PLANNING APPLICATION REFERENCE 241567
LAND TO THE EAST OF LONGWATER ROAD, FINCHAMPSTEAD, BERKSHIRE

On behalf of Catesby Strategic Land Limited and Stonebond Properties (Guildford) Limited (The Applicant), I am pleased to enclose a set of revised planning drawings which have been prepared in response to comments submitted by consultees in respect of the above application.

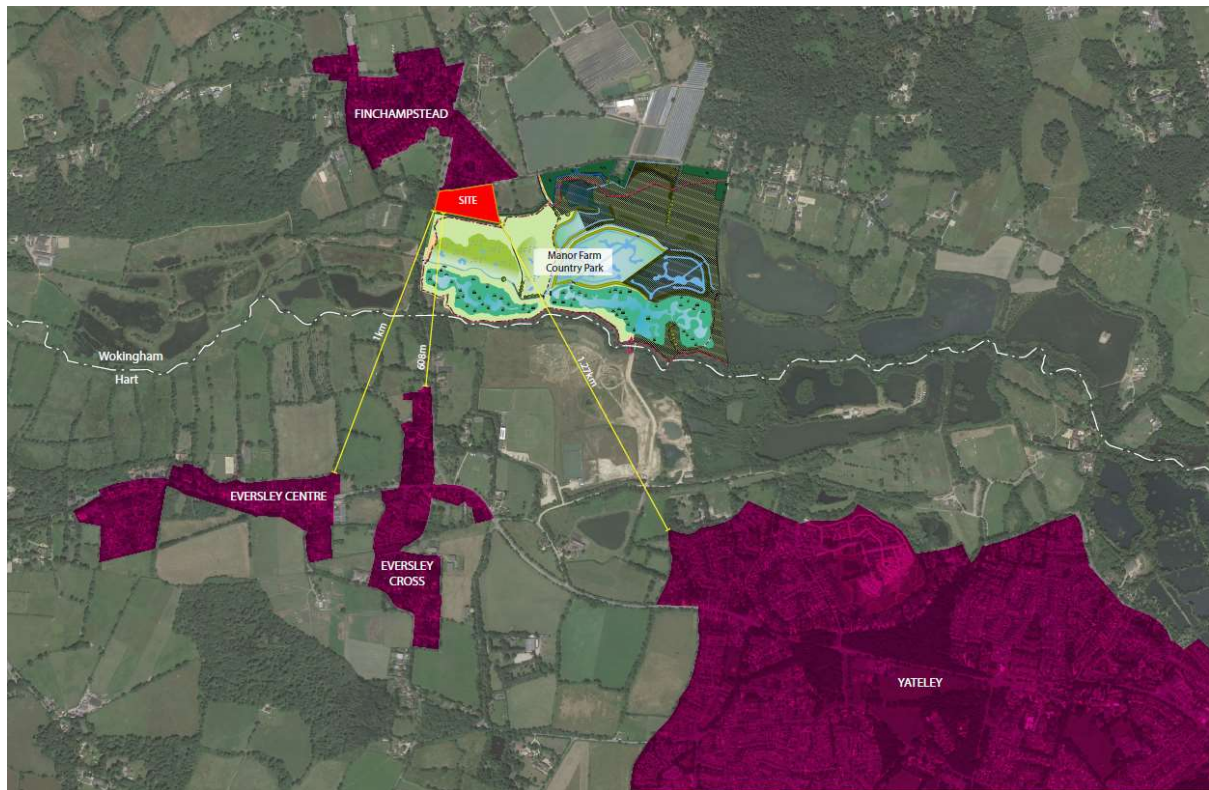
These amendments have sought to improve the integration of the development with the southern edge of Finchampstead and its relationship with the emerging Country Park to the south by shifting the built form northwards, resulting in a wider buffer between the southern-most plots and the southern boundary. Of particular note is the removal of the southern internal access road which has allowed for a wider area of public open space and a more intimate relationship between the principal elevations facing towards the open countryside, which provides increased opportunities for natural surveillance and avoids vehicular activity in this part of the site. The number of units in this part of the site has also reduced from 13 to 6 in order to provide a more appropriate transition towards the open countryside beyond. The total number of dwellings has been reduced from 40 to 38 as a result.

It has been necessary to keep the pumping station near to the southern boundary to retain the regulatory separation distance from the nearest dwellings, therefore this feature has been carefully landscaped to ensure that it assimilates into the landscape over time. Vehicular access to this pumping station will also be required but can be differentiated from

The southern boundary vegetation will continue to be retained and reinforced with native plant species to ensure that the natural screening along this boundary is managed in perpetuity, with the attenuation basin planted with marginal and native scrub vegetation along the edges for additional habitat opportunities and visual enjoyment. The remainder of the green spaces will be planted with amenity grass and species rich meadow grassland.

The proposed layout has been further enhanced by loosening the arrangement of streets and plots within the site, reducing the number of dwellings from 40 to 38 units, and setting back development from key views, such as the approach from the main entrance and the internal access routes running in a north-south orientation. In tandem, the amount of hardstanding has been reduced considerably and increased opportunities for more defined green infrastructure routes have been sought to allow for a multi-functional landscape to thrive. Careful thought has also been given to the treatment of surfaces with narrower roads leading northwards and differing surface treatments in the southern part of the site to soften the transition to the open countryside. As a result, the development has become less formal in its appearance and better reflects this edge-of-settlement location.
